**GROWTH MANAGEMENT DEPARTMENT STAFF REPORT**  
**PONTE VEDRA OVERLAY DISTRICT**  
**April 26, 2023 Public Meeting**  
**ARC 2023-04 GATE @ Shoppes of Ponte Vedra Tennis Facility**

**To:** Architectural Review Committee  
**Staff:** Sloane Stephens, Planner  
**Date:** April 11, 2023

**Summary of Request:** Applicant is requesting design approval for the construction of 12 lighted tennis courts and associated facilities that will include a clubhouse, restroom, maintenance shed, and a perimeter fence 6 feet in height along the south and west property boundaries. All relevant application materials are attached to this Staff Report.

## **Structure Elevations**

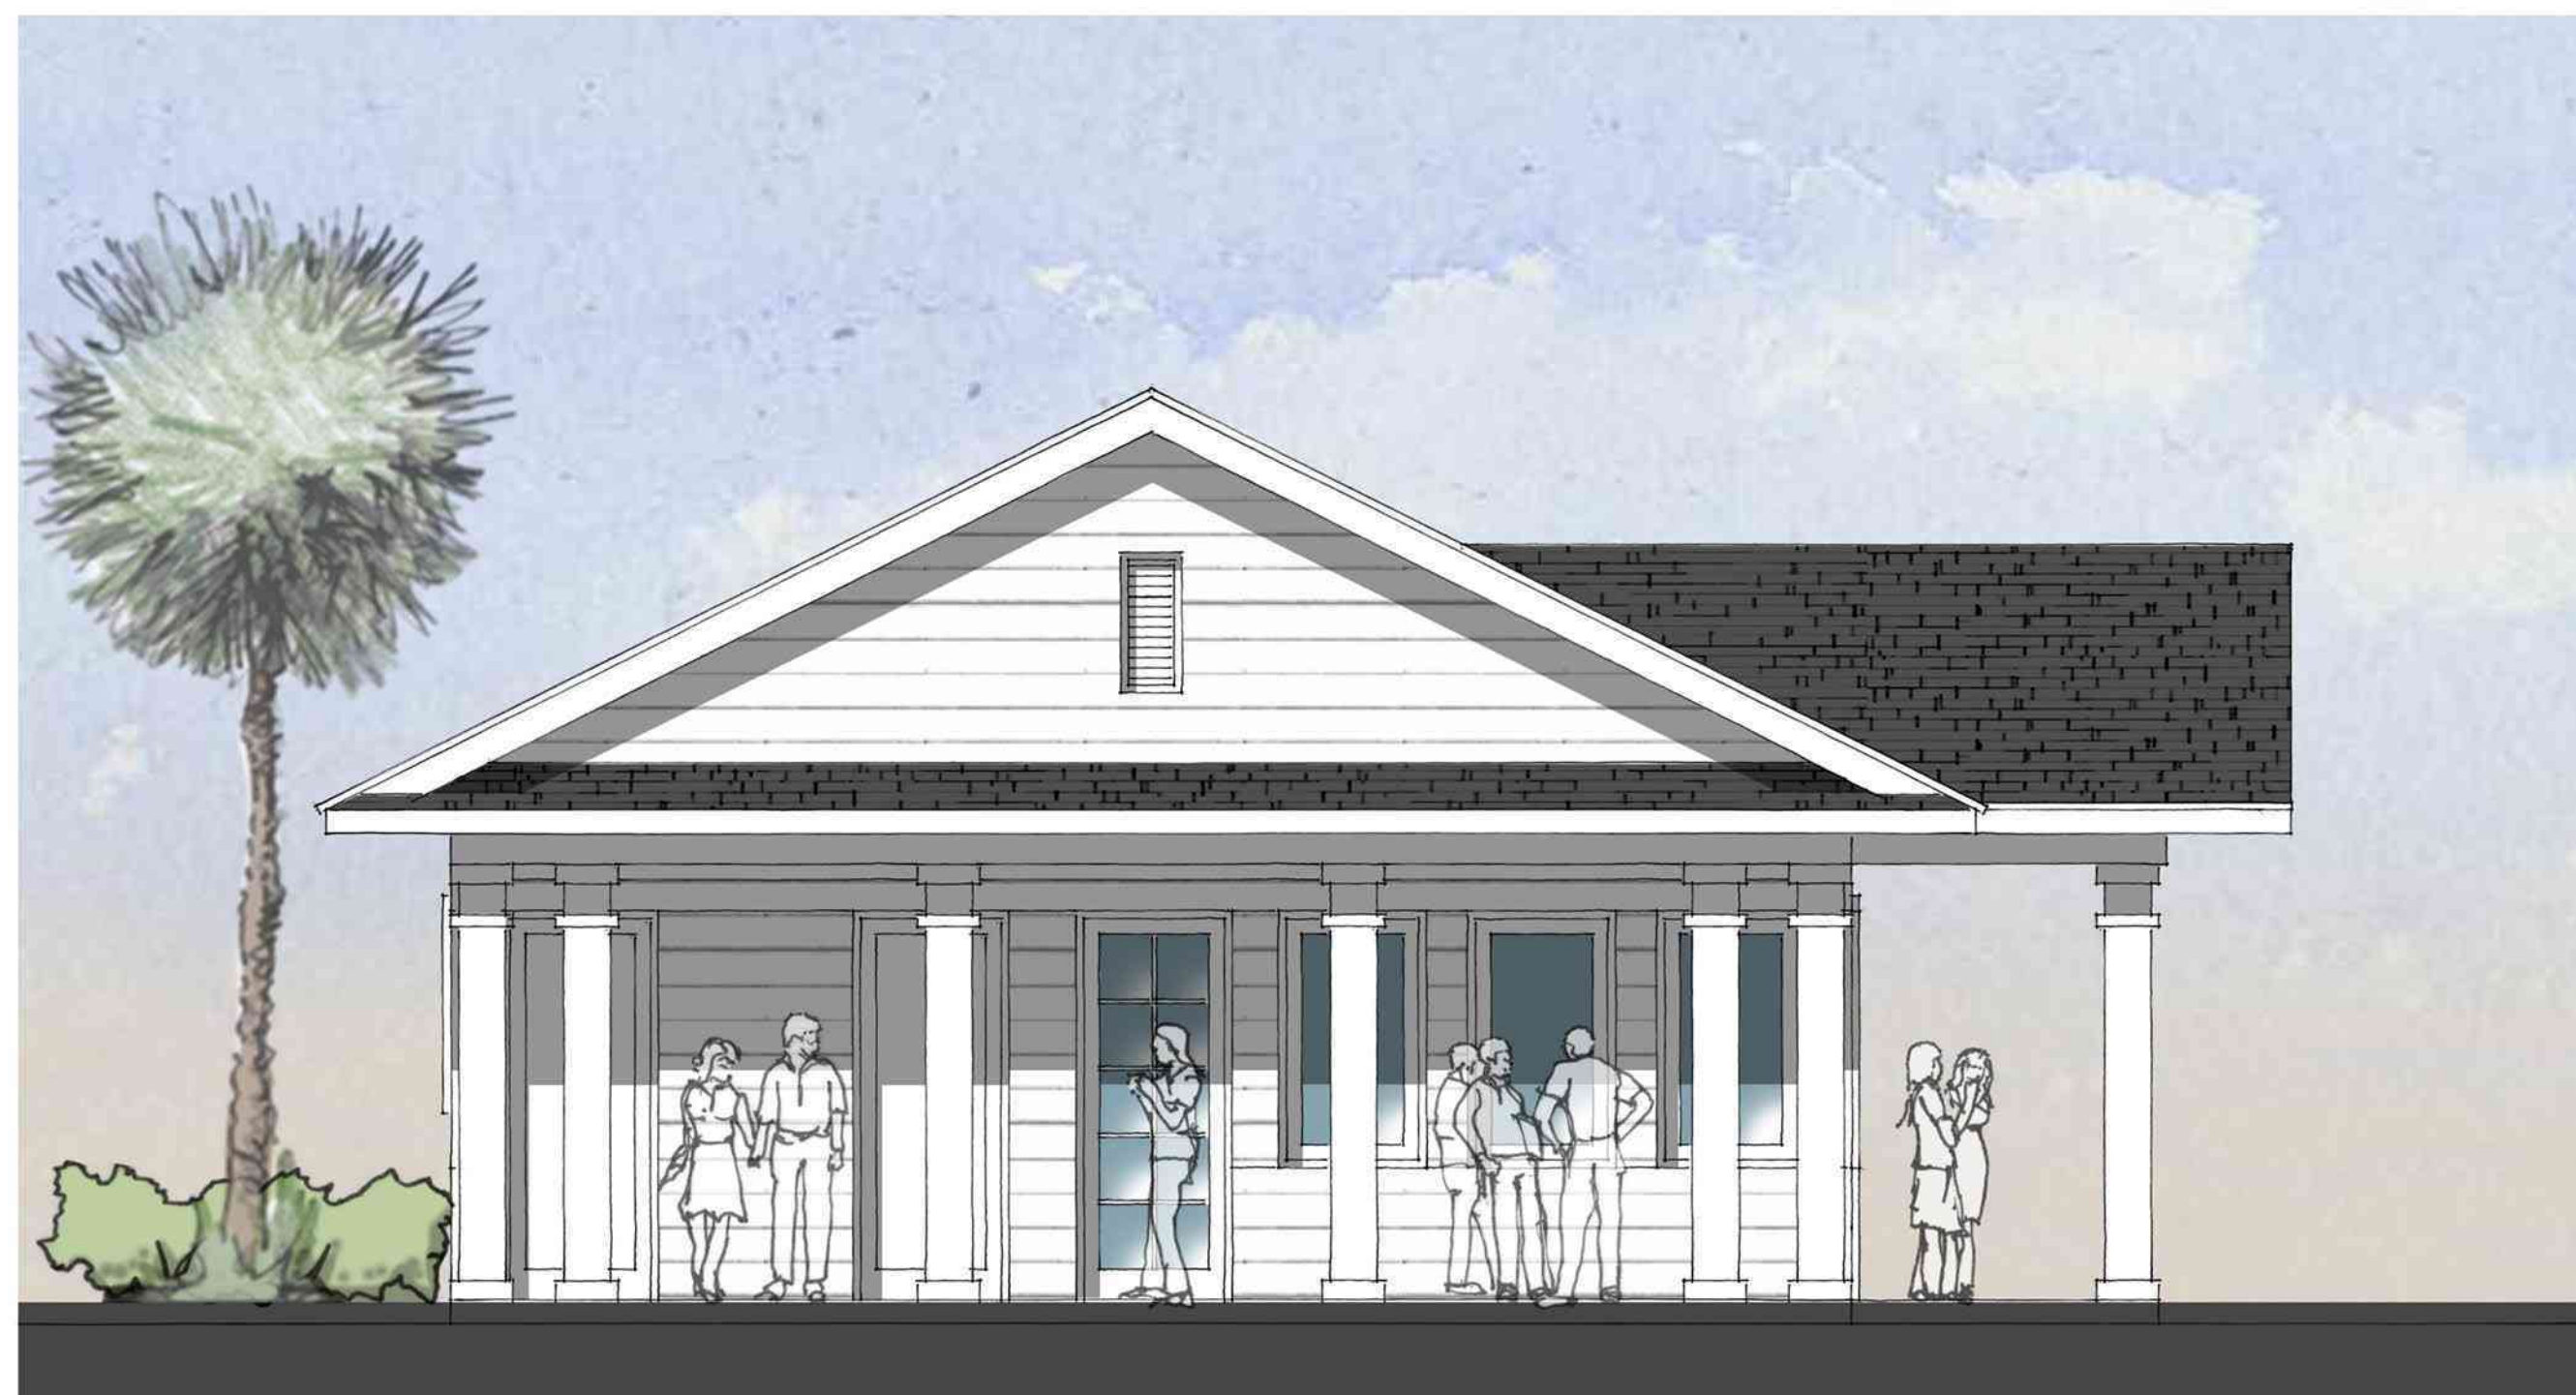
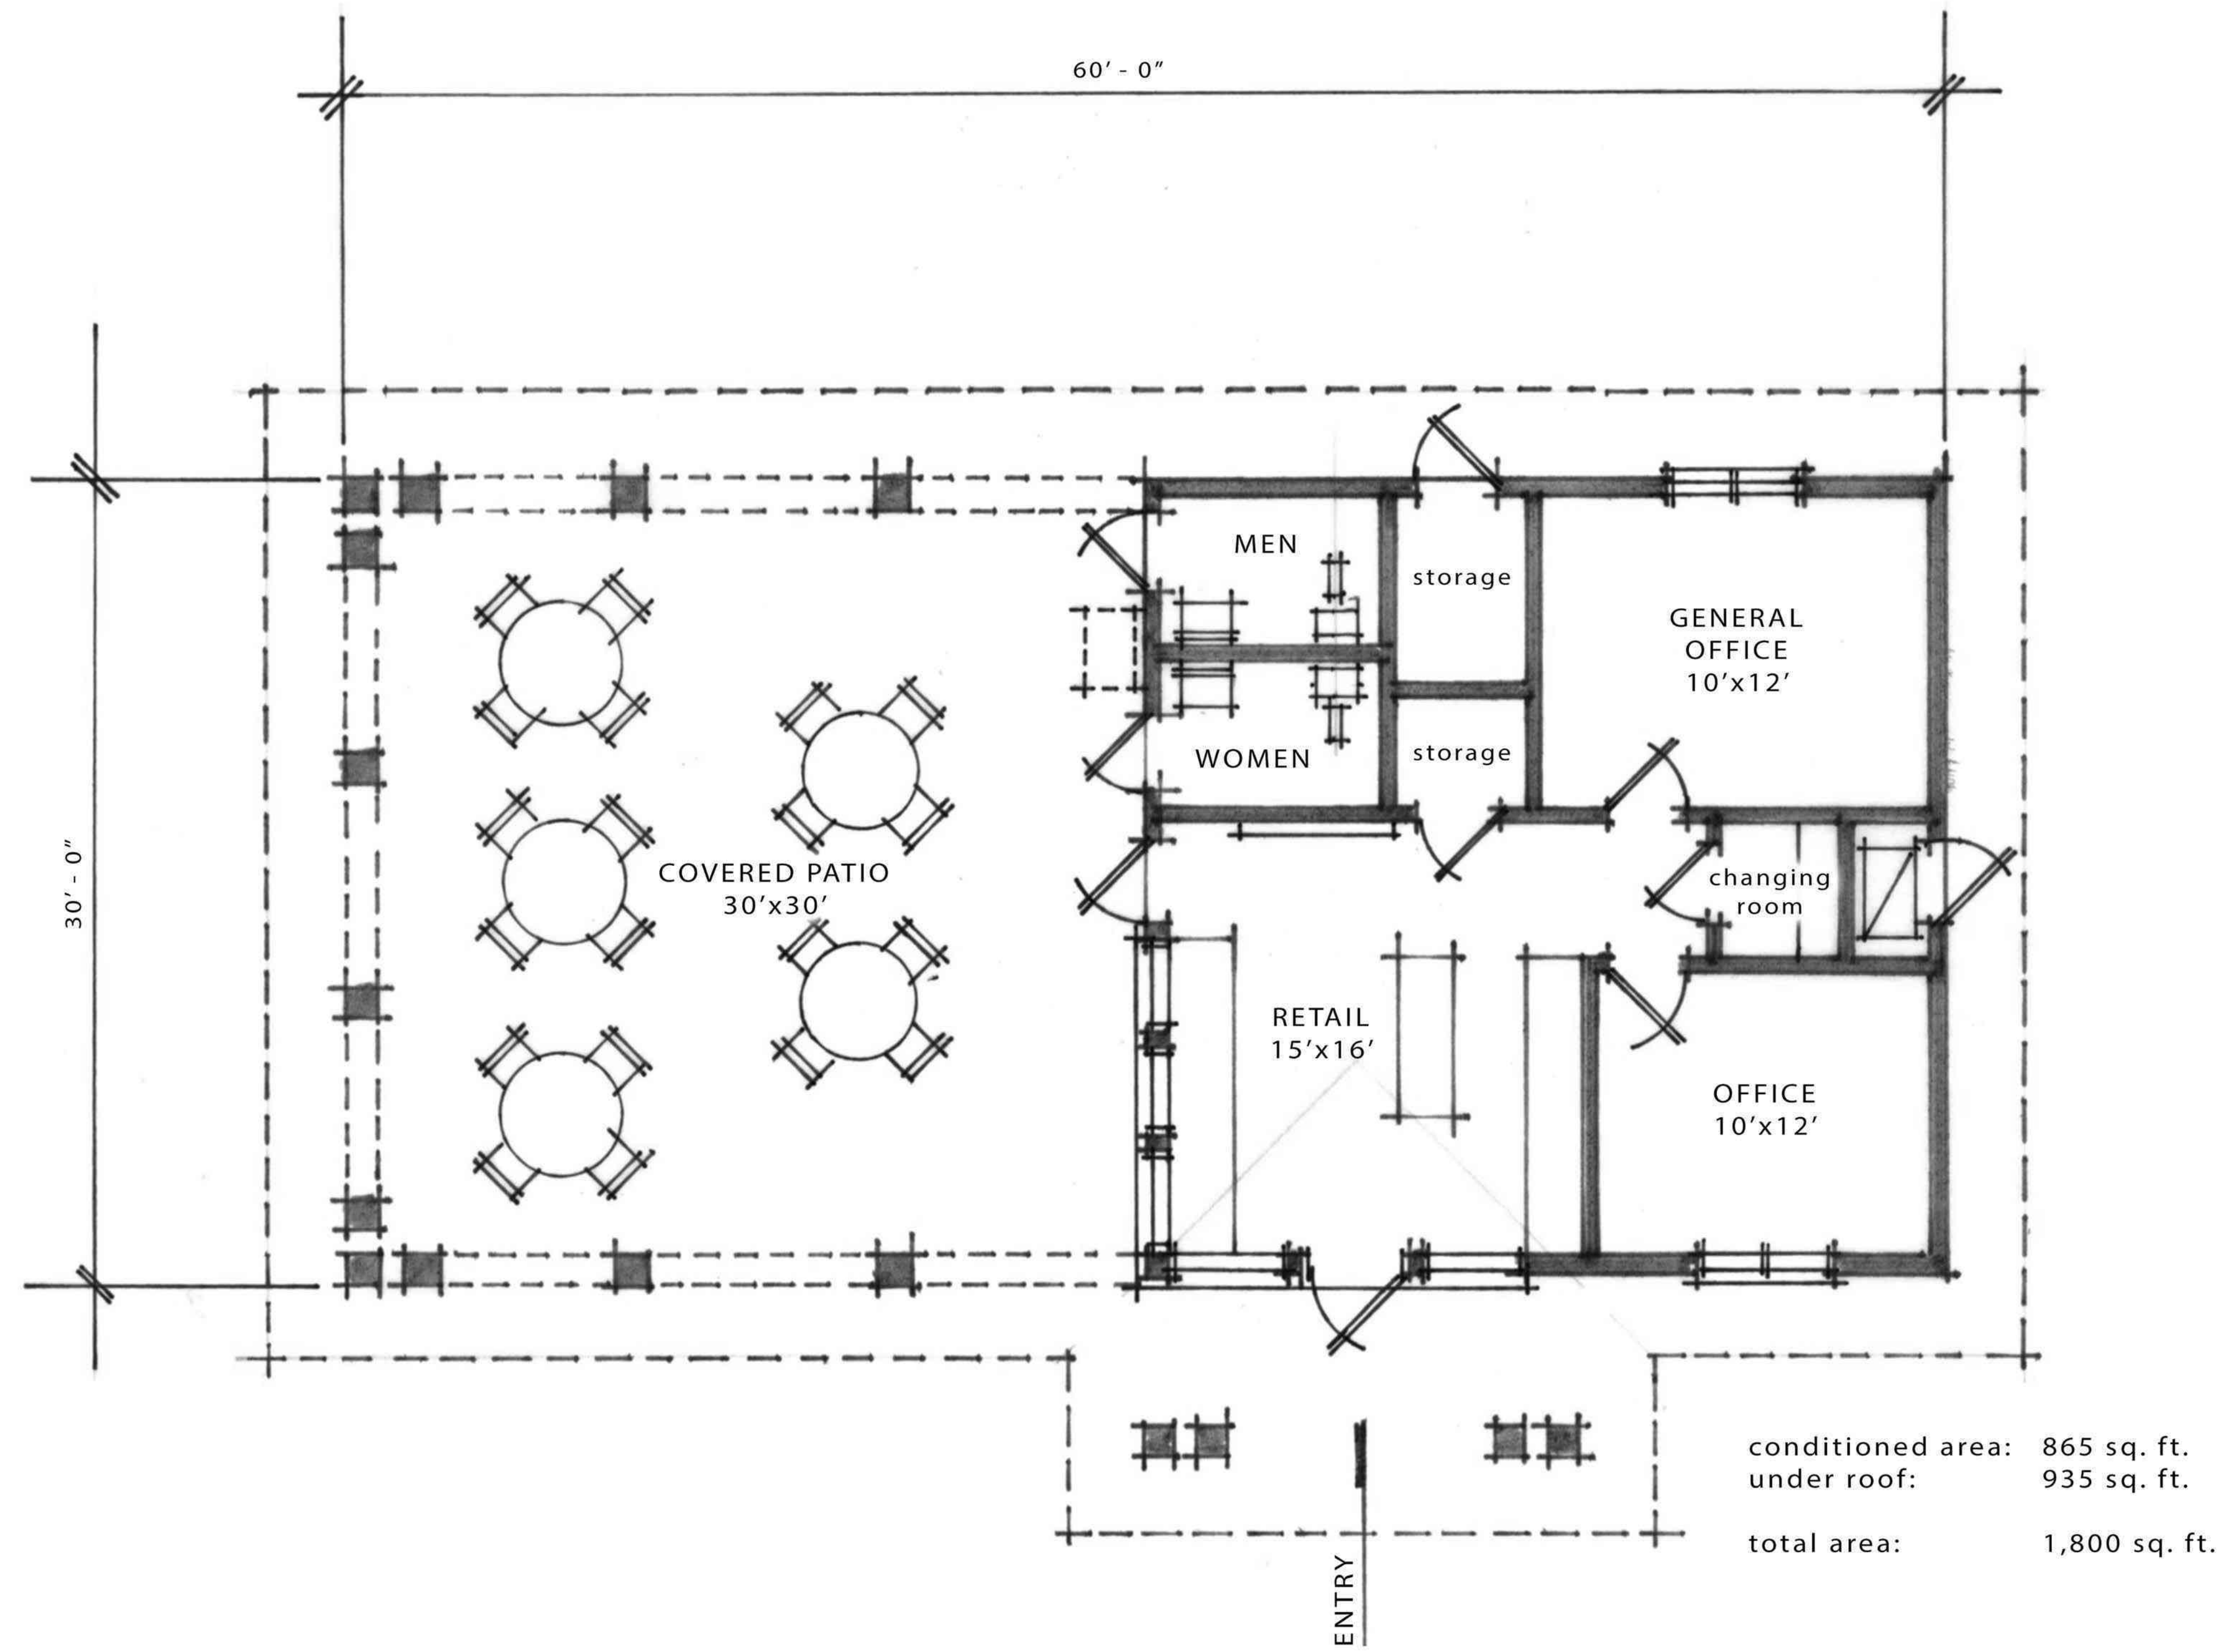
Per PVZDR VIII.Q.5.e.1, flat roofs, or the appearance of flat roofs, shall not be permitted. The roofs of all structures appear to be gable style, which have a pitch. The PVZDR does not state specific pitch requirements.

The proposed colors and materials of the project appear to be consistent with the standards set forth in PVZDR Section VIII.5.d.e. The requirements for the color palette being Earth Tones with no more than three colors per building, excluding roof color, are met.
